September 29, 2015

**SUBJECT: DEMONSTRATION / DELIVERY HOLD - Customer Satisfaction Program 15B31**  
Certain 2015 Model Year Focus Vehicles with DPS6 Automatic Transmission  
Flexplate-to-Clutch Nut Replacement

FIGURE 1

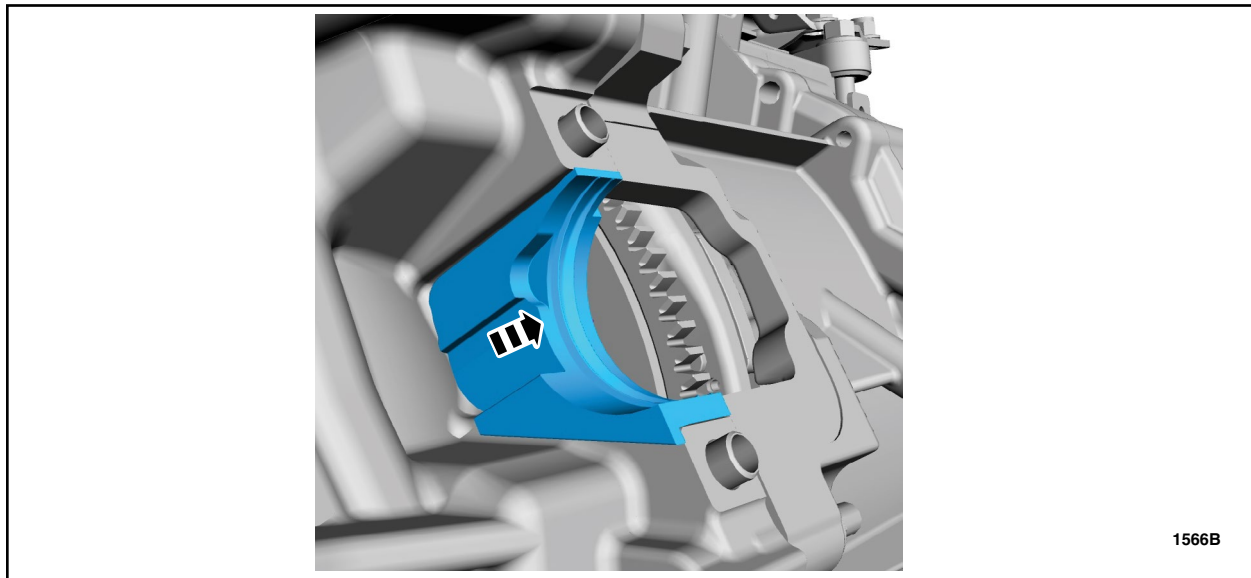
1. With the vehicle in NEUTRAL position it on a hoist. Please follow Workshop Manual (WSM) procedures in Section 100-02.
2. Disconnect the battery ground cable. Please follow WSM procedures in Section 414-01.
3. Remove the engine oil filter adapter. Please follow WSM procedures in Section 303-01C.
4. Remove the starter motor. Please follow WSM procedures in Section 303-06B.
5. Remove the starter motor insulator. See Figure 1.

3. Install the starter motor insulator. See Figure 1.
4. Install the starter motor. Please follow WSM procedures in Section 303-06B.
5. Install the engine oil filter adapter with a *new* gasket and *new* oil filter. Please follow WSM procedures in Section 303-01C.
6. Reconnect the battery ground cable. Please follow WSM procedures in Section 414-01.
7. Check and top off the engine oil as needed.

**FIGURE 2**

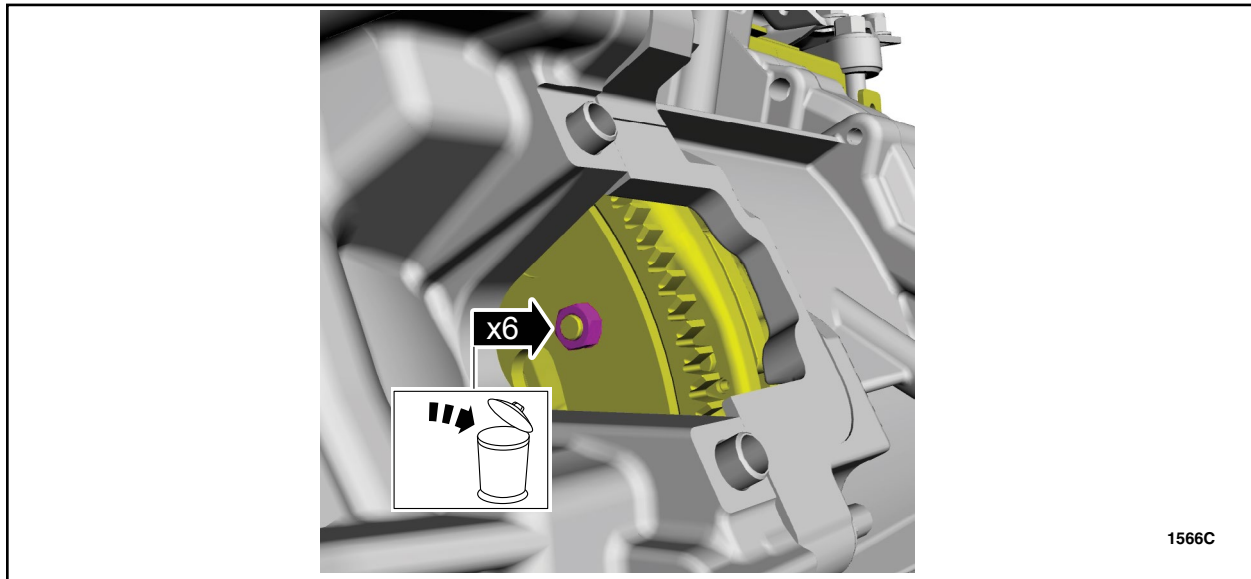
6. Using a magnetic socket, remove and discard the six (6) flexplate-to-clutch nuts. See Figure 2.

**FIGURE 3**

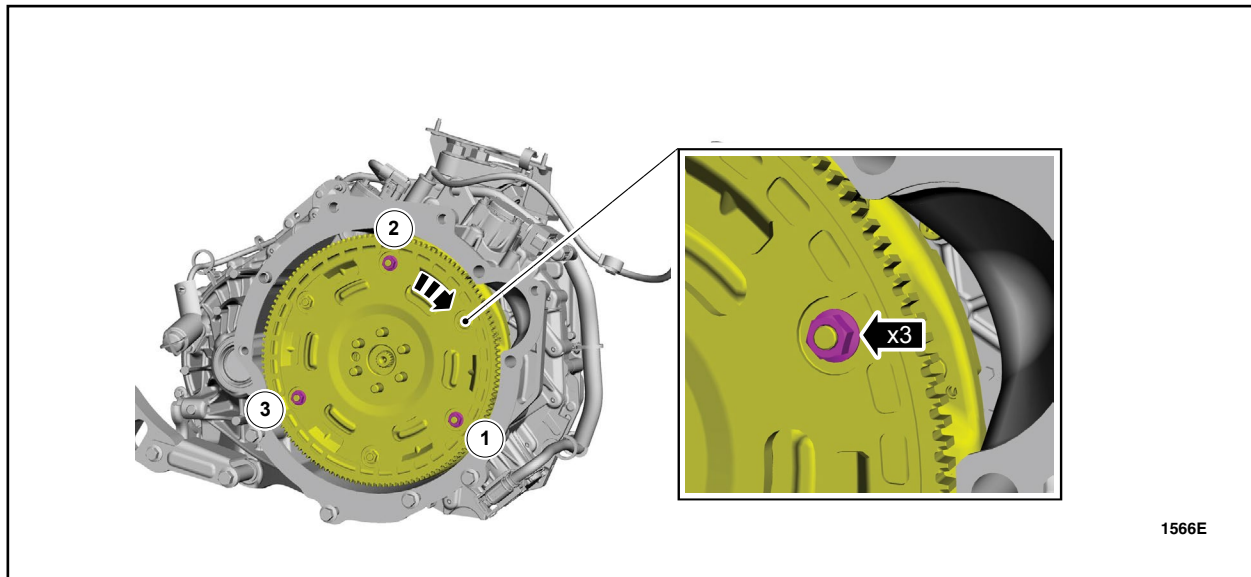
1. Install three (3) of six (6) *new* flexplate-to-clutch nuts in locations shown. Tighten in sequence as shown. See Figure 3.

- Tighten to 12 Nm (106 lb.in)

**FIGURE 4**

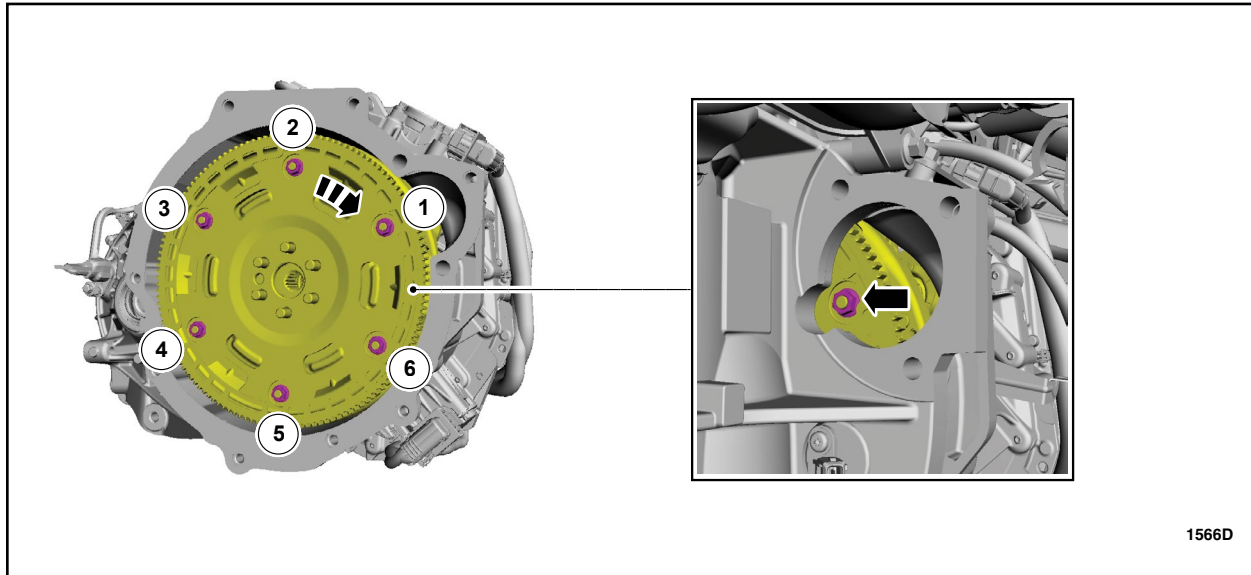
2. Install the three (3) remaining *new* flexplate-to-clutch nuts. Tighten all six (6) *new* flexplate-to-clutch nuts sequence as shown. See Figure 4.

- Tighten to 25 Nm (18 lb.ft)
